Release Note for AIC SAS 6G 3U16EOB-2 Expander

Jan 14, 2013

Supported Configuration

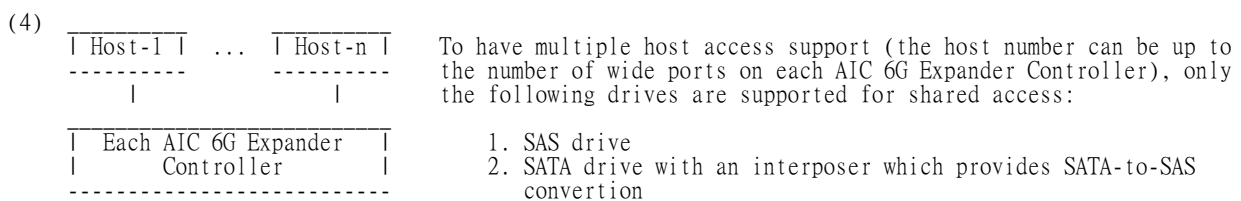
1. Remove the section "Supported Topology", and add two sections, "Supported Configuration" and "Unsupported Configuration"
